## Access Compliance Report Public Rights-of-Way (Curb Ramps)

Intersection ID: 27620 Main Street: CAMFIELD\_ST Cross Street: ELM\_LN Location: SW

ADA ID: 500AC85F6A7A Ramp Type: PerpDiag Initial Pass/Fail: Fail Overall Compliance: No Severity Score: 21.25

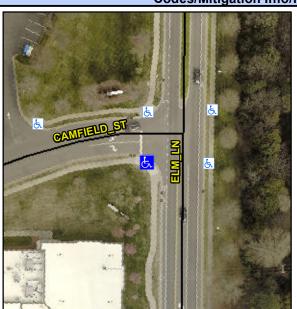
Not Found, R304.5.1, R304.2.2

Compliance Description		Data	Compliance Description		Data
N/A	Ramp Length (in)	45.0	No	Ramp Slope (%)	9.2
No	Ramp Width (in)	47.0	Yes	Ramp XSlope (%)	0.7
N/A	Flare Type LT	N/A	N/A	Flare Type RT	N/A
N/A	Flare Slope LT (%)	N/A	N/A	Flare Slope RT (%)	N/A
N/A	Flare Traversable LT?	N/A	N/A	Flare Traversable RT?	N/A
N/A	Landing Length (in)	N/A	N/A	DWS Provided?	N/A
N/A	Landing Width (in)	N/A	N/A	DWS Contrast?	N/A
N/A	Landing Slope (%)	N/A	N/A	DWS Length (in)	N/A
N/A	Landing X Slope (%)	N/A	N/A	DWS Full Width?	N/A
N/A	Landing Curb? (Y/N)	N/A	N/A	DWS Offset (in)	N/A
N/A	Shared Landing?	N/A			
N/A	Gutter Ponding?	N/A	N/A	Gutter Slope (%)	N/A
N/A	Gutter Lip Ht (in)	N/A	N/A	Gutter X Slope (%)	N/A
N/A	Painted X Walk1?	No	N/A	Painted X Walk2?	No
	X Walk 1 Direction	To E		X Walk 2 Direction	To N
N/A	X Walk 1 Width (in)	N/A	N/A	X Walk 2 Width (in)	N/A
	X Walk 1 Slope (%)	0.5		X Walk 2 Slope (%)	0.9
	X Walk 1 X Slope (%)	0.7		X Walk 2 X Slope (%)	0.4

Remove & Replace Curb Ramp With Two New Directional Ramps or Equivalent.
